Re: Enchantment Carpets
4815 Mcleod Rd
Traffic Circulation Layout
Architect's Stamp dated 03-29-18 (F17-D099)

DRAINAGE AND TRANSPORTATION INFORMATION SHEET (REV 11/2016)

ENCHANTMENT CARPET ADDITION
SITE PLAN
4815 MCLEOD RD NE
ALBUQUERQUE, NM 87109
PROJECT # 1801

AS-1.0

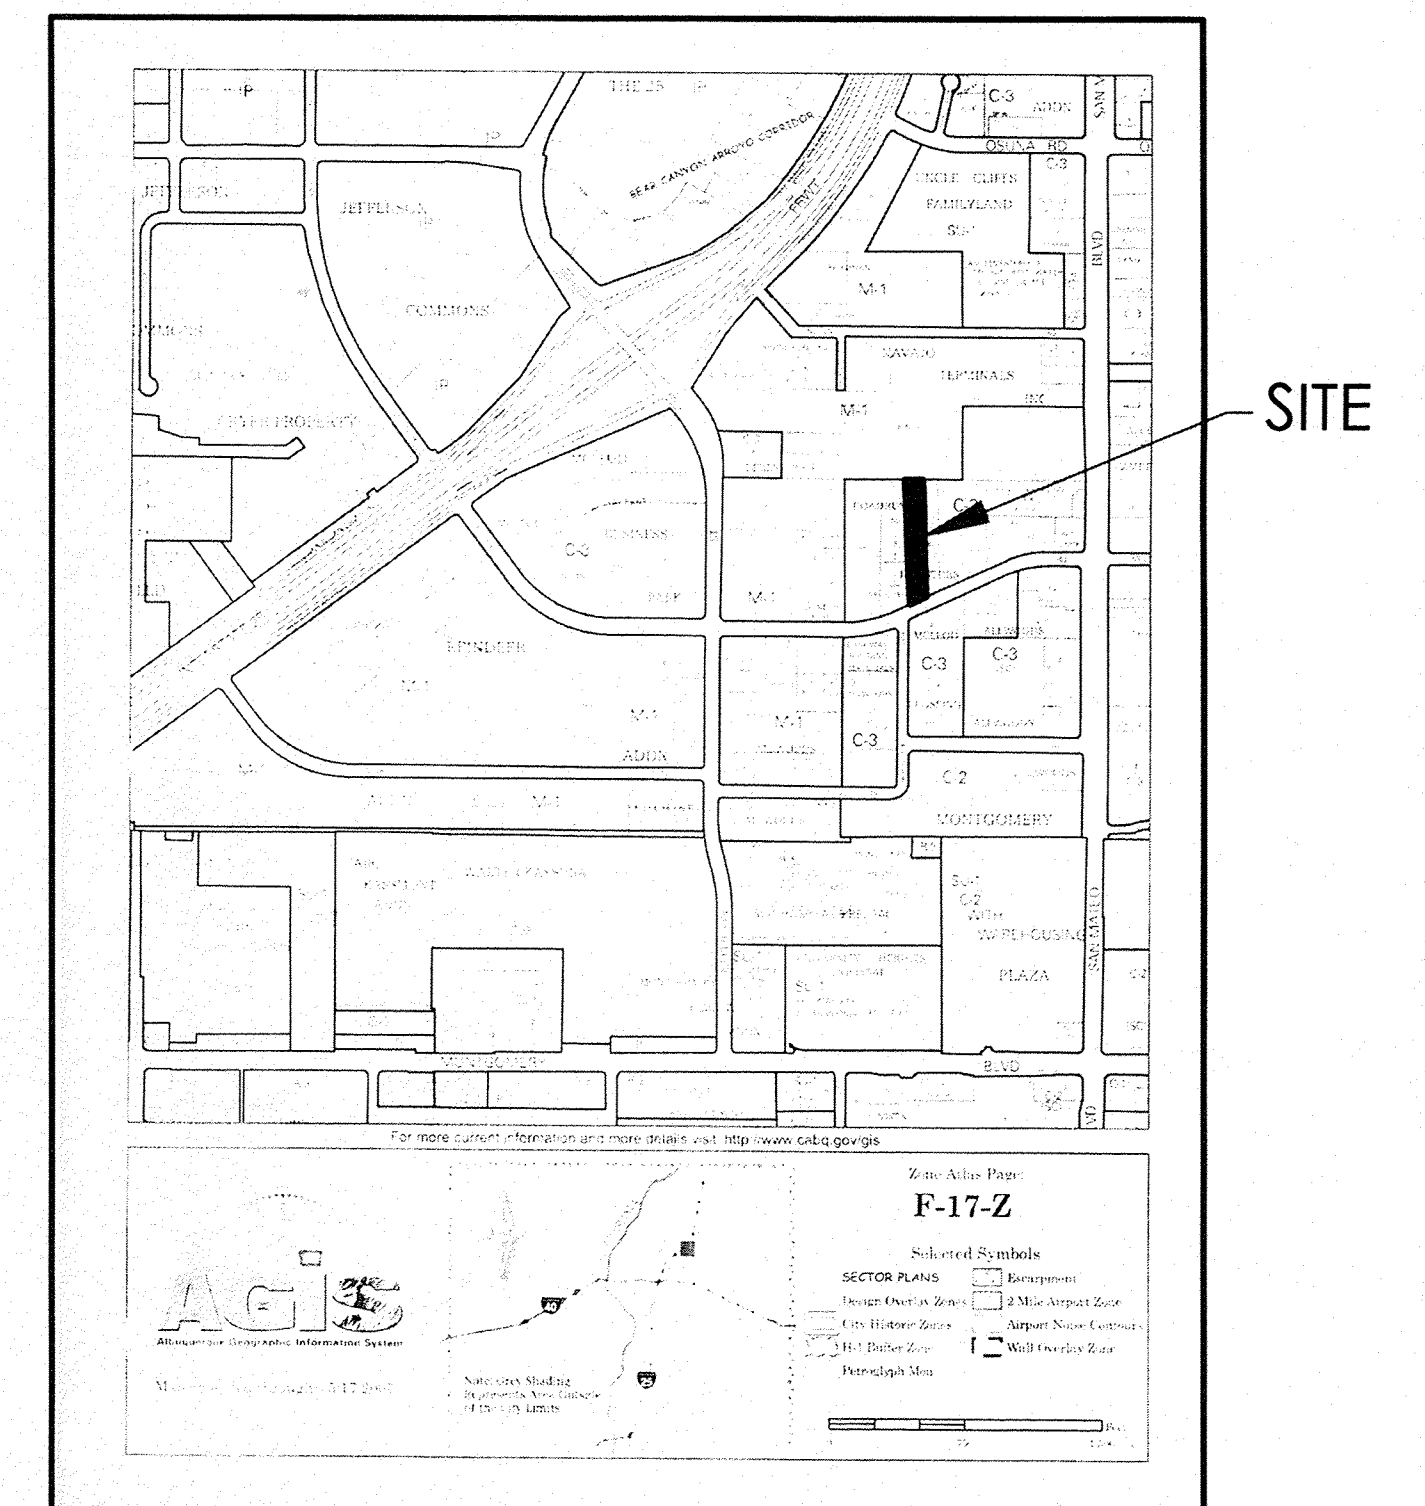
The TCL submittal received 03-29-18 is approved for Building Permit. A copy of the stamped and signed plan will be needed for each of the building permit plans. Please keep the original to be used for certification of the site for final C.O. for Transportation.

- **Permeable Pavement or Permeable Pavement System:** The permeable surface or permeable pavement system shall be designed to meet the requirements of the City Engineer and/or their designee(s). Alternate paving materials shall be installed and maintained according to manufacturer's specifications. Pavement must support the expected loading and traffic and be sufficiently durable.
